SEWAGE DISPOSAL SYSTEM

HOWARD COUNTY
BUREAU OF ENVIRONMENTAL HEALTH
461-9933

P. 45362
A. REPAIR

SITE INSPECTION SHEET

DORFMAN RES.
 SLATER ASSOC. 7.9.96

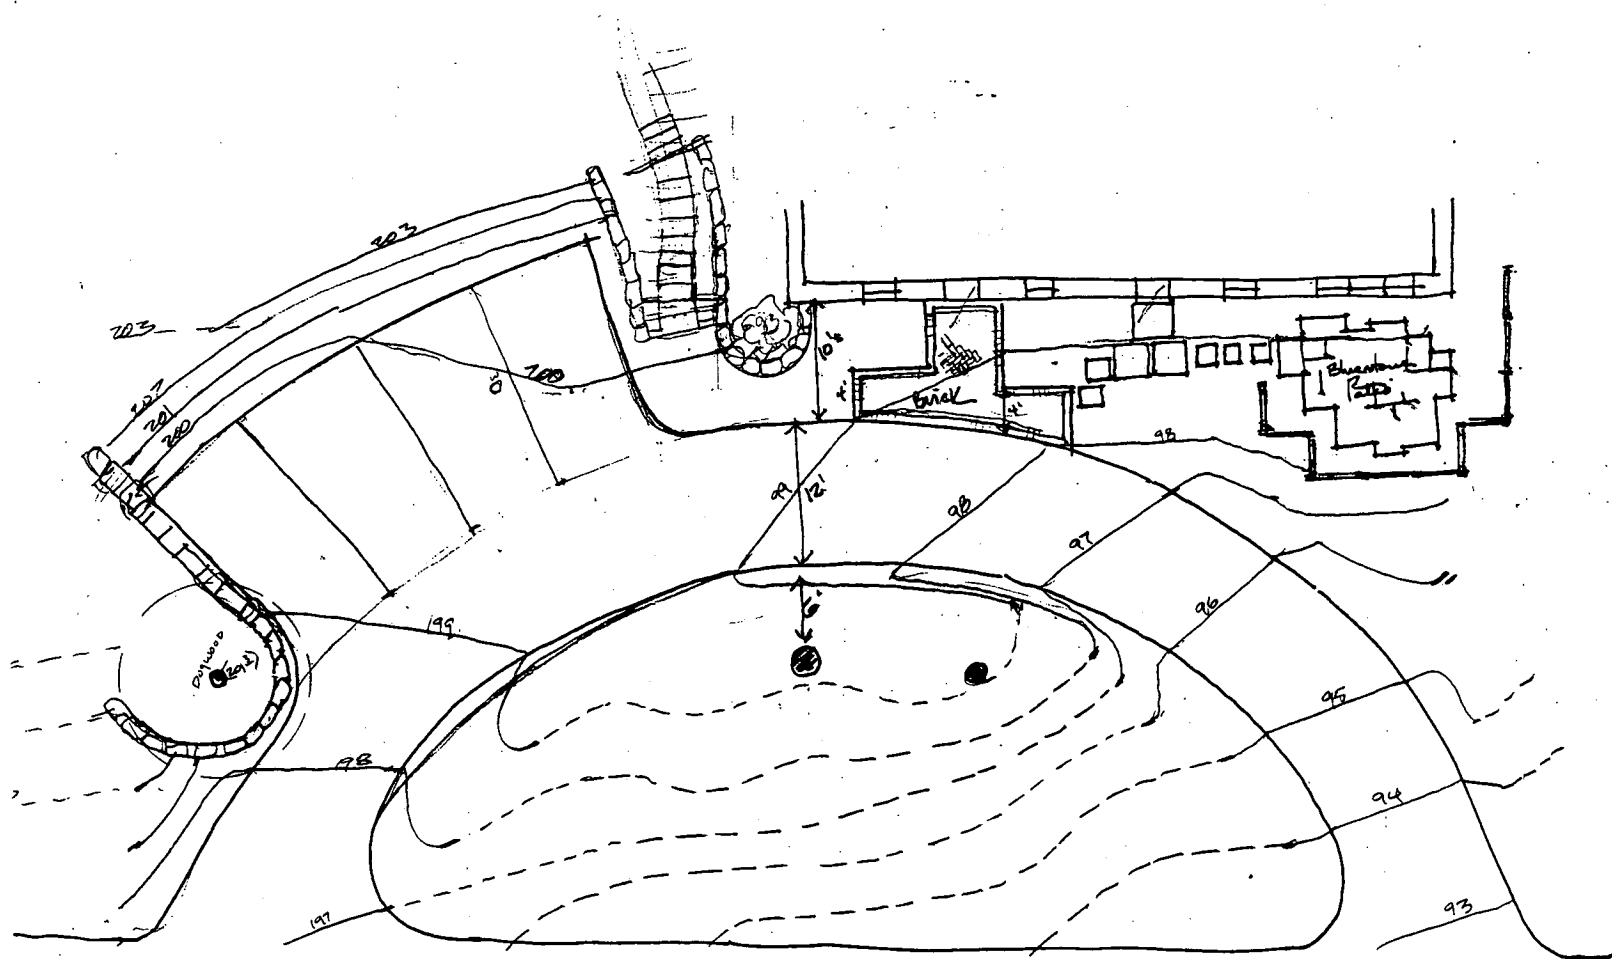
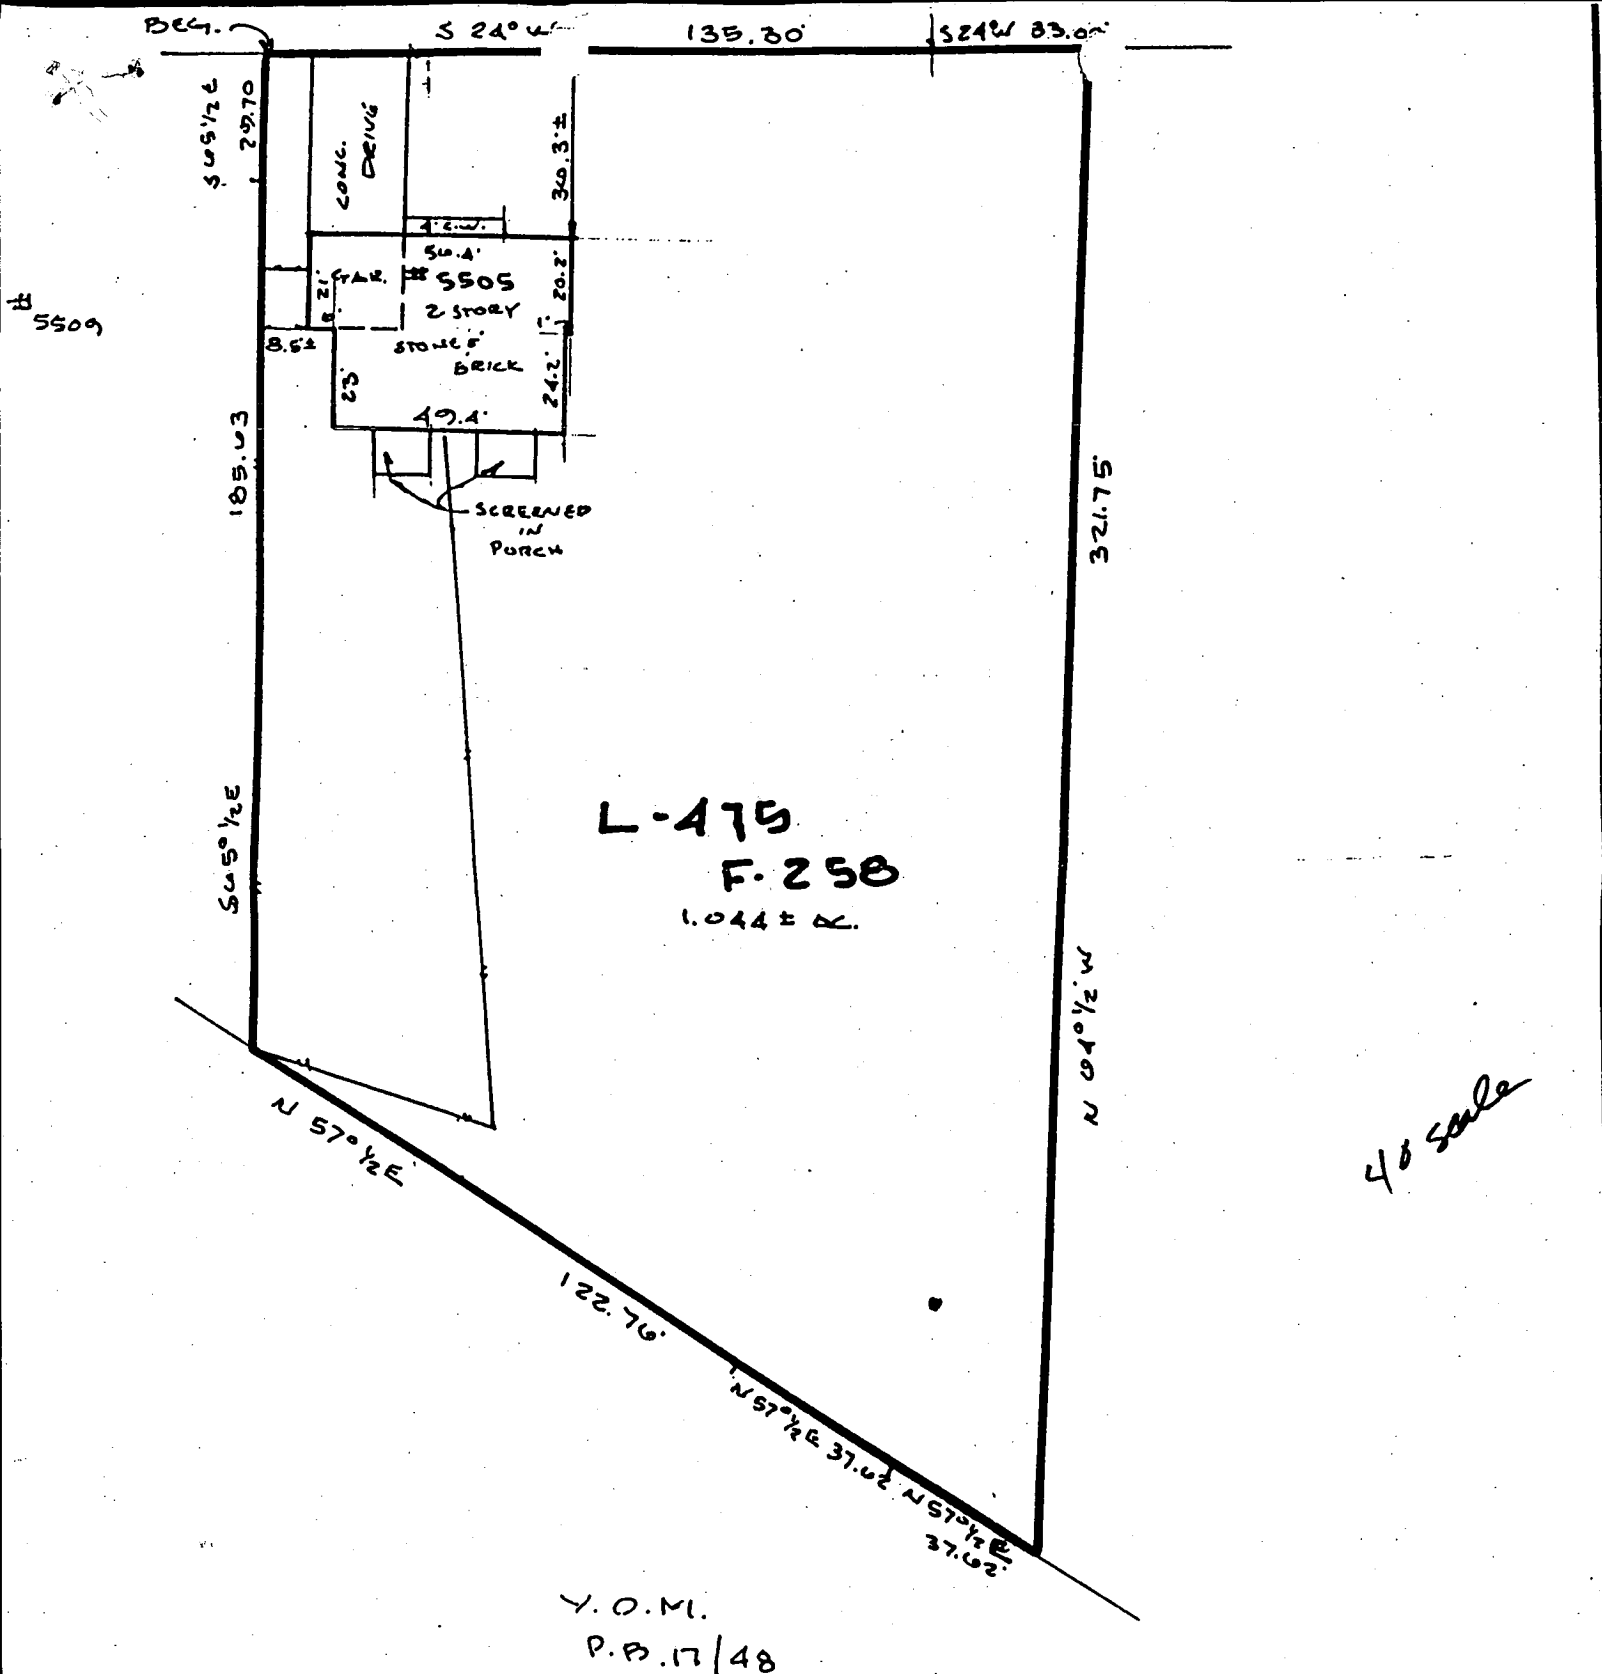
PROPOSAL: ~~about~~ 6" pipe of unknown purpose in conflict w/ driveway. request recommendation on well or septic status & remediation

COMMENTS: 7/24/96 STANDPIPE OF CONCERN IS D/W C/O; PLAN^{IS} TO ADD ADD'L PARKING AREA + CIRCULAR DRIVE; ADVISED AGENT ~~THAT~~ OK TO REGRADE IN D/W VICINITY, BUT BETTER TO ADD REPAIR SYSTEM + ABANDON D/W; HE WILL HANDLE + CALL IF NEC. OR
